Docket Number:	01-AFC-07C
Project Title:	01-AFC-7C Russell City Energy Company
TN #:	204817
Document Title:	Russell City Energy Center Amendment No. 5 VIS-10
Description:	Amendment of Visual Resources Condition of Certification VIS-10
Filer:	Jonathan Fong
Organization:	Russell City Energy Center
Submitter Role:	Applicant
Submission Date:	6/1/2015 3:20:57 PM
Docketed Date:	6/1/2015

**RE: AMENDMENT # 5
RUSSELL CITY ENERGY CENTER
DOCKET NO. 01-AFC-7C**

Russell City Energy Center

Amendment No. 5

COLOR TREATMENT AND OFF-SITE LANDSCAPE CONCEPT

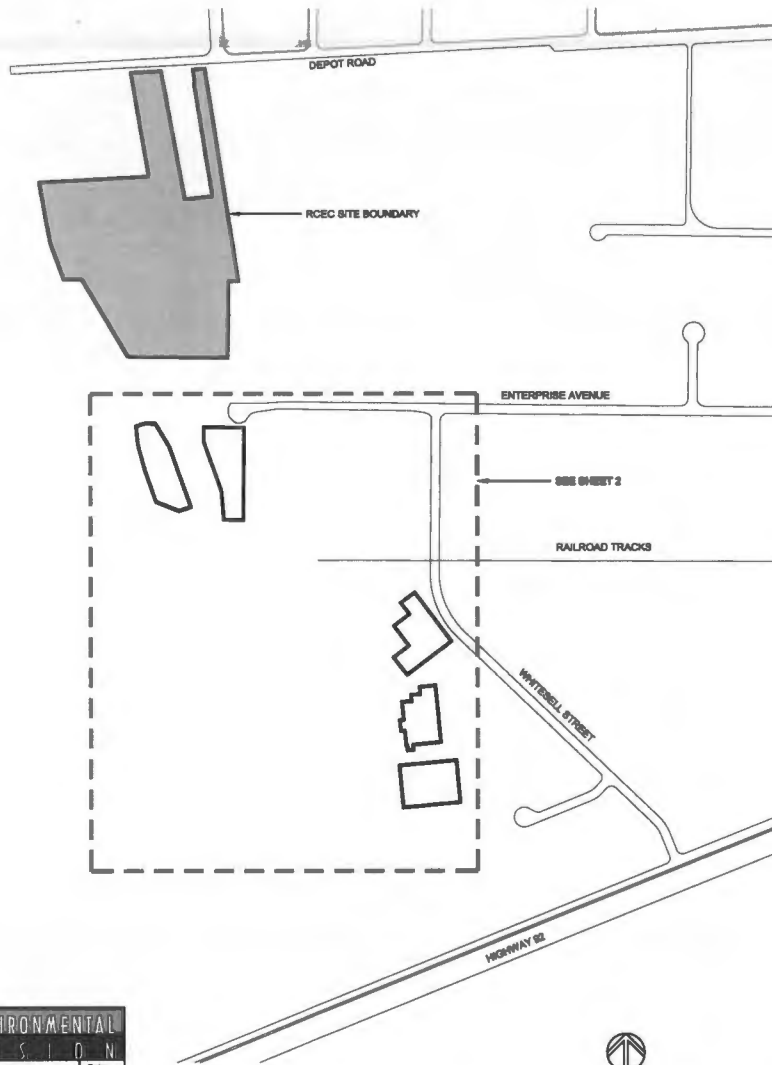
Therefore, the project owner proposes to amend VIS-10 to allow the project owner to provide additional visual enhancement measures in place of vegetation in certain locations. Specifically, instead of planting vegetation in front of the warehouses the project owner has substantially reduced the contrast between the background and the off-site buildings and structures along the west side of the warehouse and industrial park complexes that line the eastern edge of the shoreline. Instead of planting trees to buffer the view of light-colored walls currently seen from the shoreline, the existing walls in the area have been repainted in more muted colors as approved by the CPM and the City of Hayward. The painting was performed at the project owner's expense, with the full consent and cooperation of the owners of the buildings. Colors were selected in consultation with the building owners, the City and the CPM. This accomplishes visual mitigation objectives without the potential undesirable consequences of planting trees, i.e., blocking views from the properties, allowing birds of prey to perch on trees, causing damage to underground sewers or unnecessarily consuming water during drought conditions. In addition, the project owner has received consent from the City of Hayward to carefully plant a row of selected trees along the western edge of a City owned parcel, to help block views of a tall wide back wall of a large warehouse located at the terminus of Enterprise Avenue, without potential damage to existing sewers or interfering with future use of the City parcel. Figures 2 and 3 of the Visual Enhancement Plan lists two tree species that weren't selected (Peppermint Gum and Evergreen Ash) for the revised planting plan because these species were not available from local nurseries and because of the preference of the City for other listed species.

The VIS-10 visual enhancement plan is attached (Attachment 1). Page 2 of the plan shows the color treatment and general off-site landscape concept. Page 5 shows the view of the project area before the visual enhancement is applied. Page 6 is a visual simulation of the project area after implementation of the plan.

VIS-10 ~~Prior to the start of construction, the project owner shall prepare and implement an approved off-site landscaping~~ **visual enhancement** plan. **The visual enhancement plan shall substantially reduce the contrast between the background and the off-site buildings and structures** along the west side of the warehouse and industrial park complexes that line the eastern edge of the shoreline wetlands by ~~Consistent with Measure 3 of the Visual Mitigation Plan, the project owner shall installing trees~~ **surface treatments on publicly visible buildings.** ~~The extent of the landscaping area, as shown in Visual Resources Figure 14 shall be expanded to include the berm from Breakwater Avenue north to Johnson Road. Trees shall be planted close together to create a dense screen. Trees planted along the edge of the Whitesell Business Park parking lot shall be pruned up as they grow to allow westward views from the parking lot to the shoreline open space. Trees planted close to the walls of the warehouses shall be allowed to take on a bush-like form to maximize their screening potential.~~
